CITY OF MADISON

PLAN OF PROPOSED IMPROVEMENT

531 W WASHINGTON AVENUE

Revised 2/14/2024
Sheet P1
Sheets U1-U4
Sheet X1

UTILITIES PLAN & PROFILE - EASEMENT STORM
531 WEST WASHINGTON AVENUE
 M:\DESIGN\Projects\14500\CAD\Sewers\14500SWR-PipeNetwork_REV1.dwg
 CONTRACT NO: 9274
 14500
 U-3

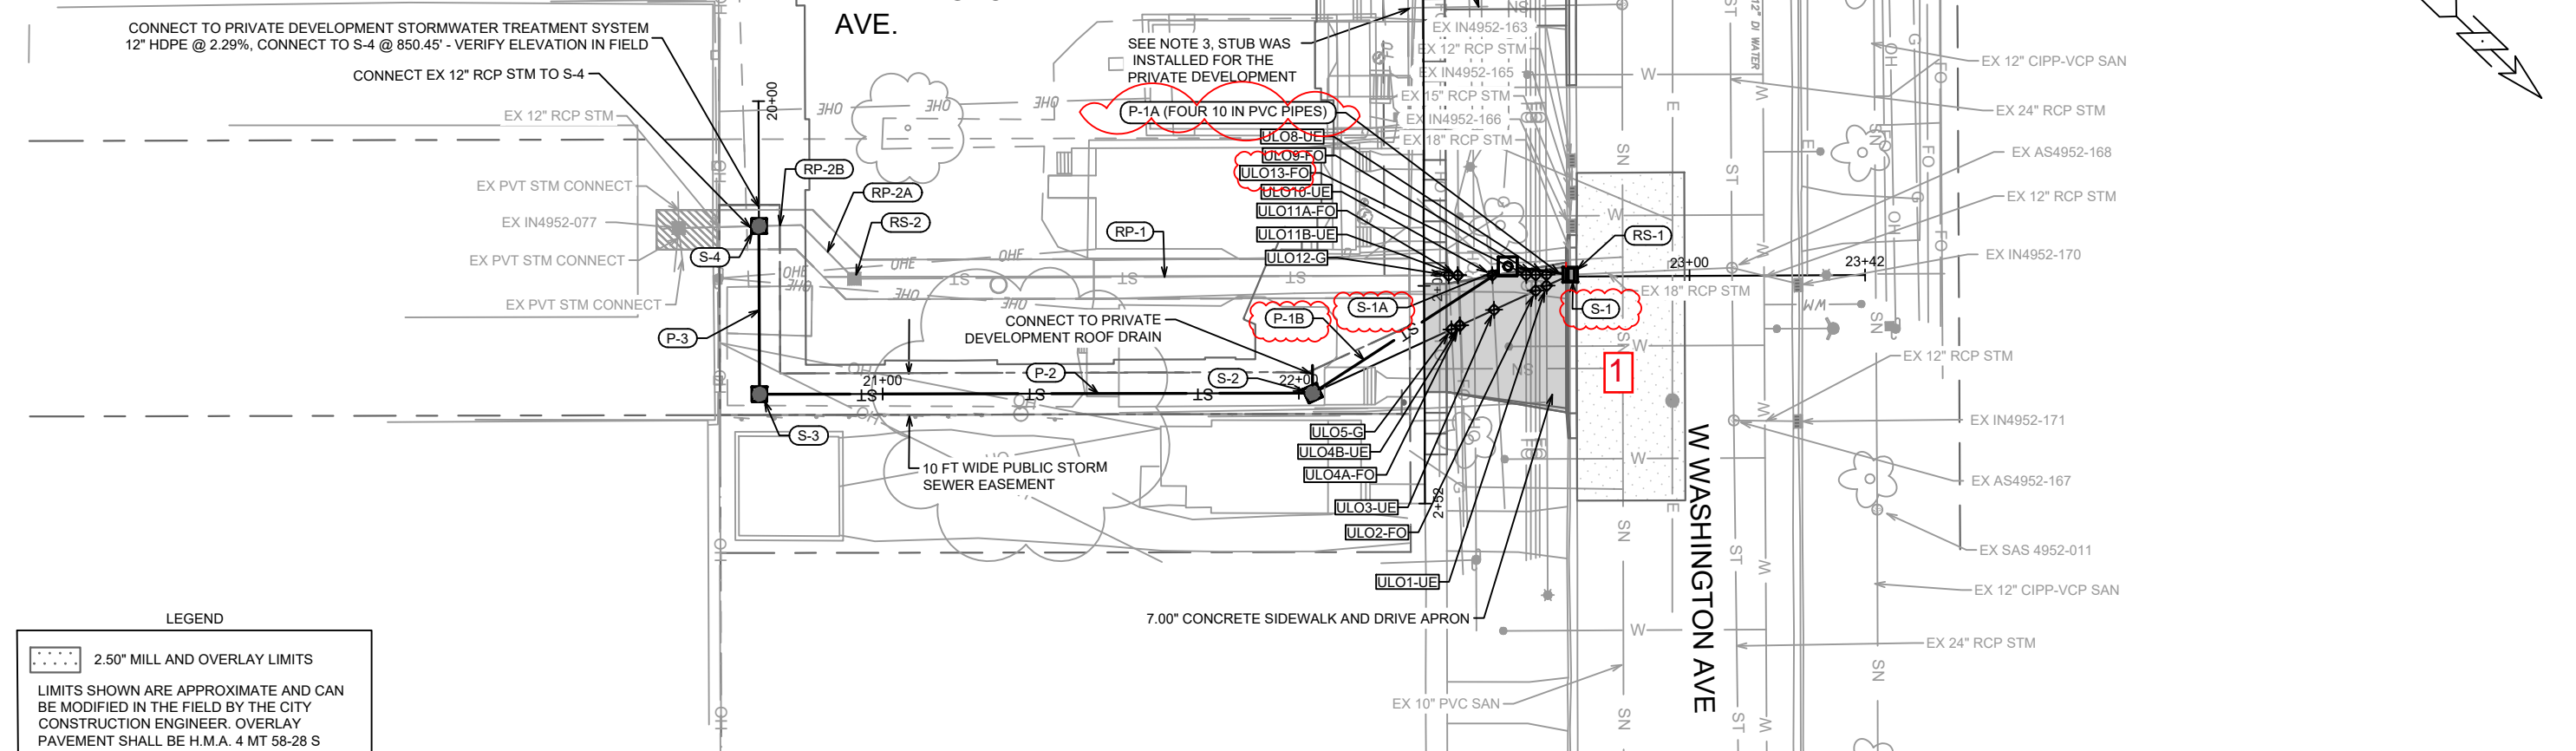
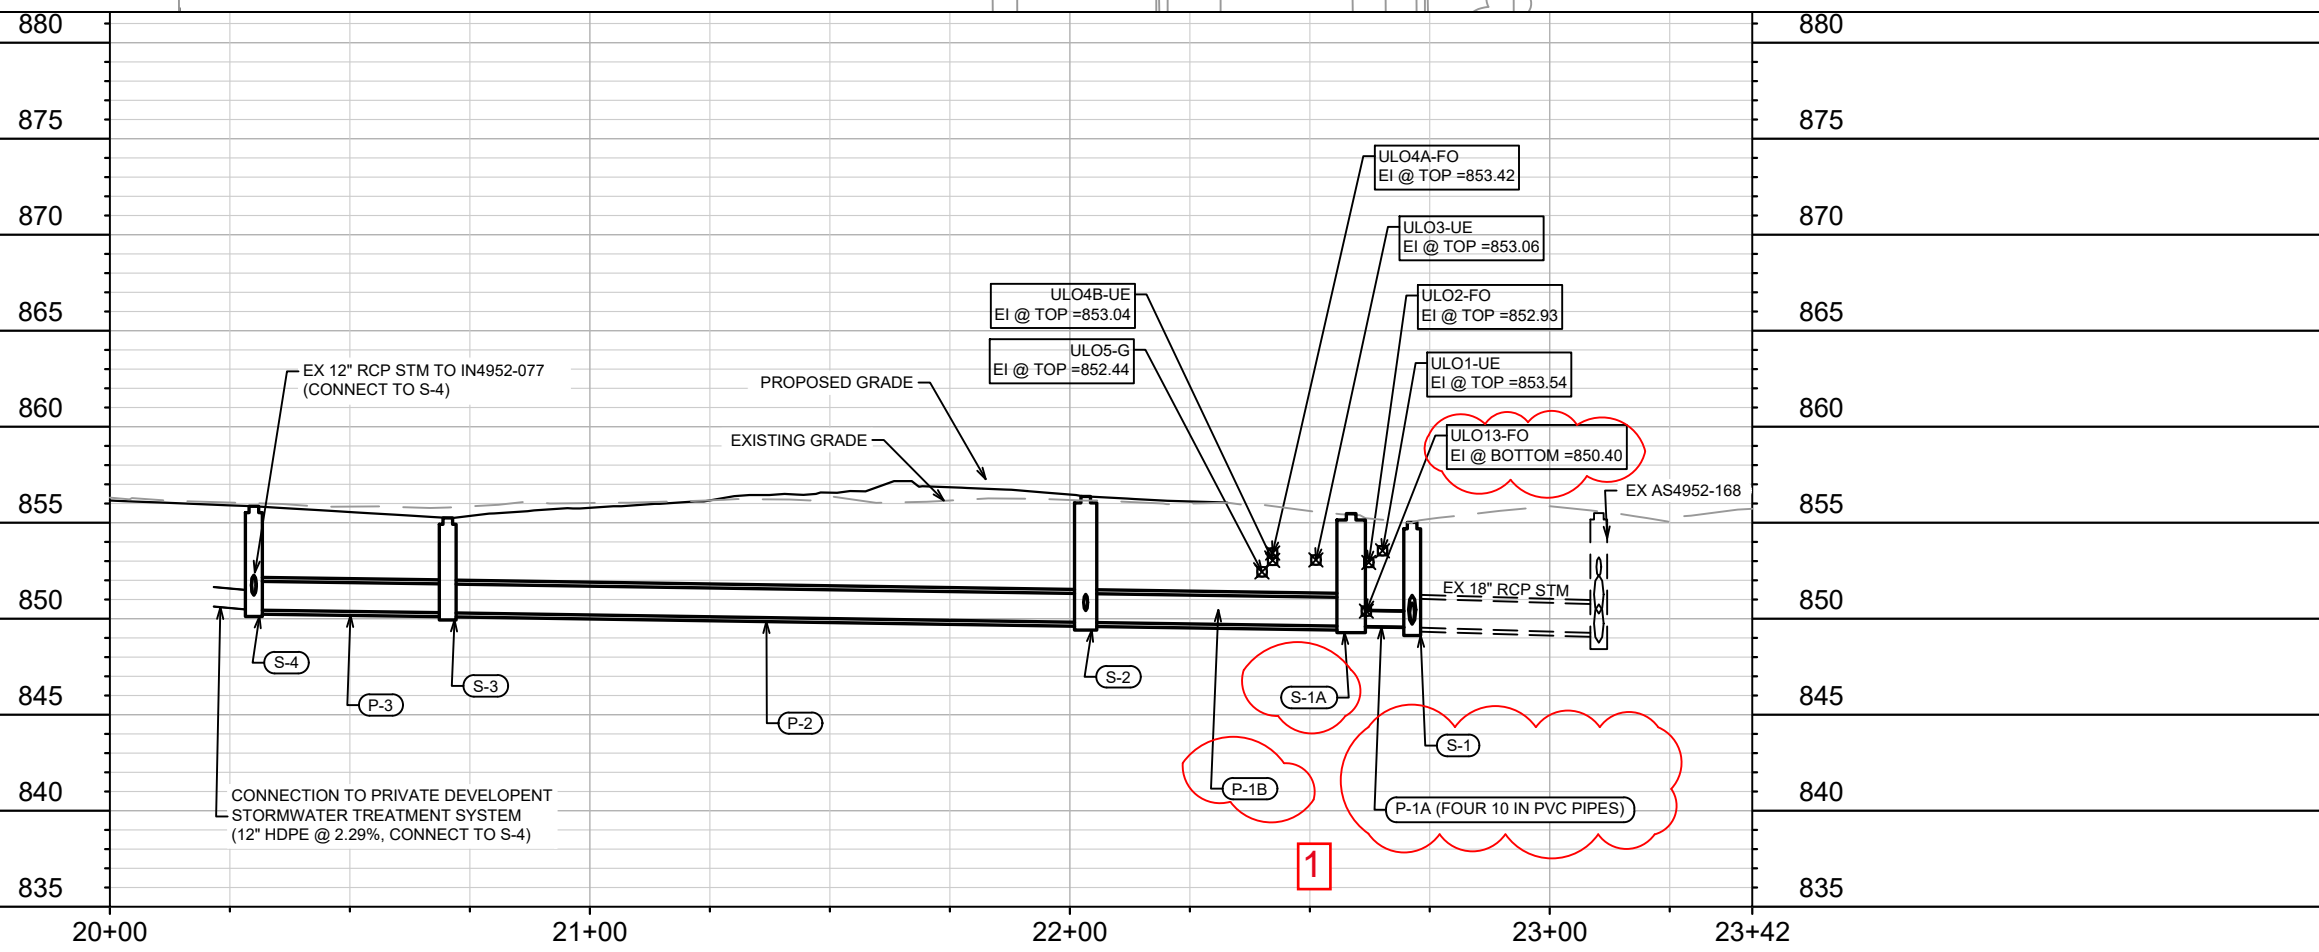
REVISION #1: 02/14/2023
 1. REVISED STORM SEWER LAYOUT BASED ON FIELD DISCOVERY OF ADDITIONAL UTILITIES.

CROSS SECTIONS
 531 W WASHINGTON AVE
 M:\DESIGN\Projects\14500\CAD\Streets\14500EN-Xsections.dwg

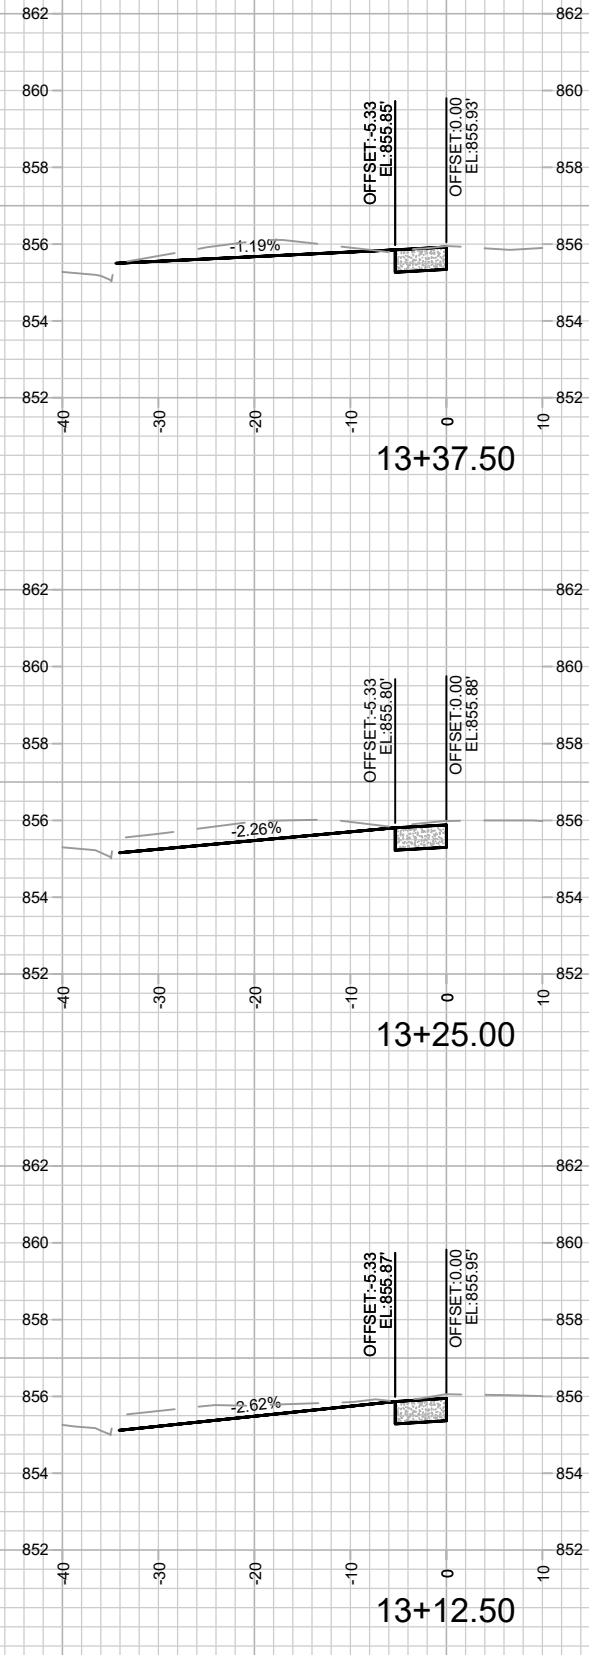
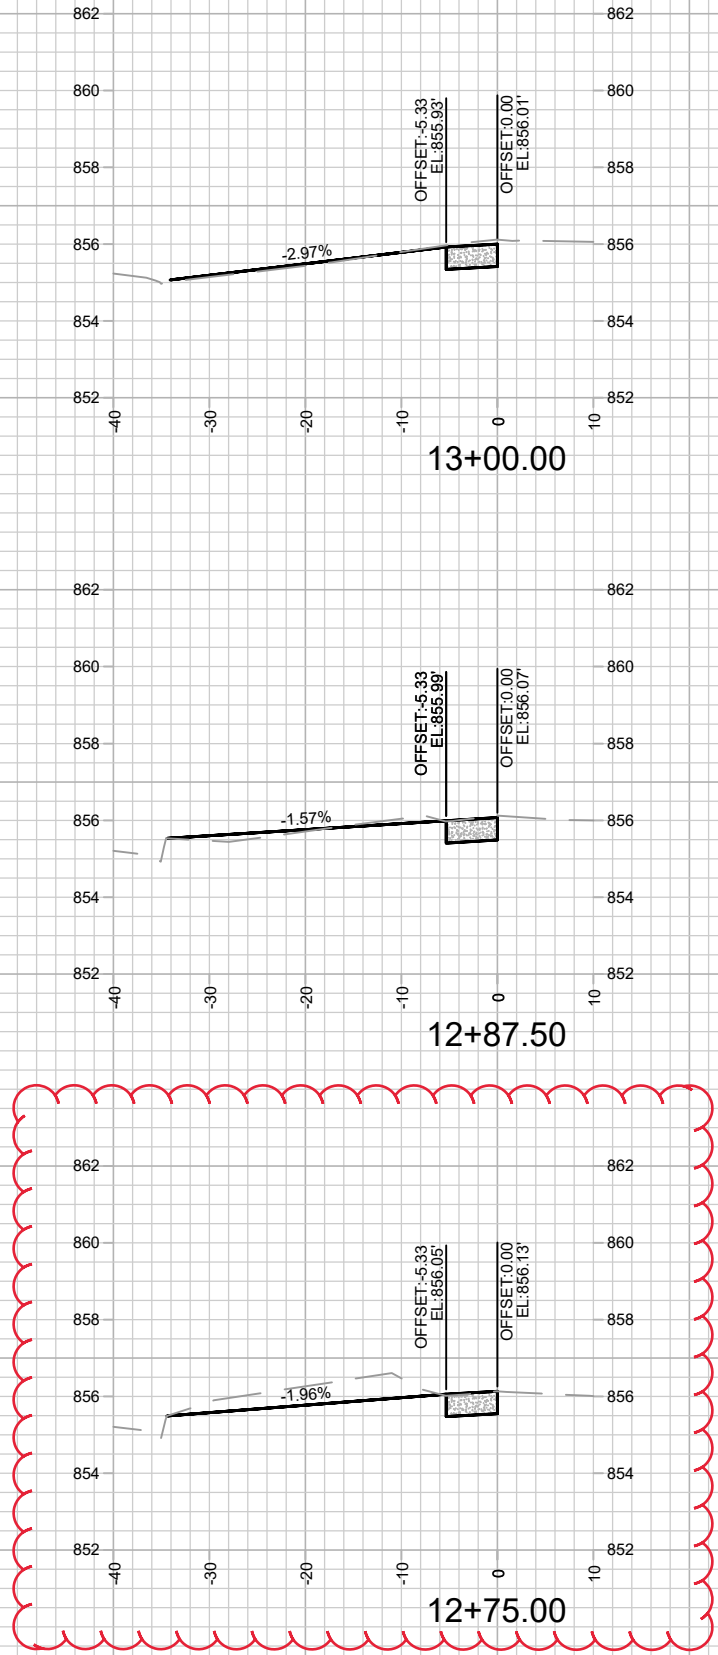
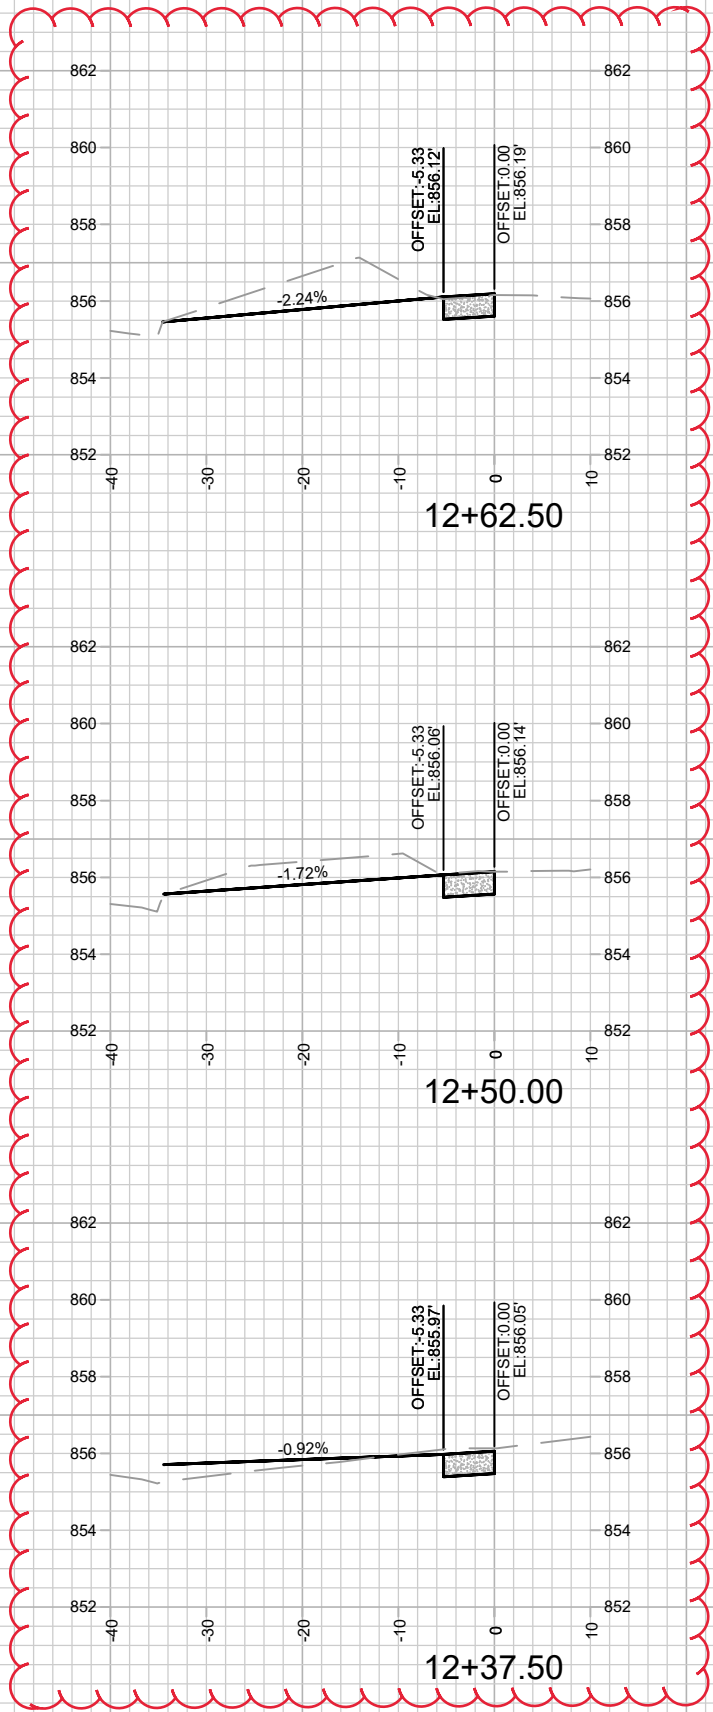
REVISION #1: 02/14/2024
 1. ADDED CROSS SECTIONS
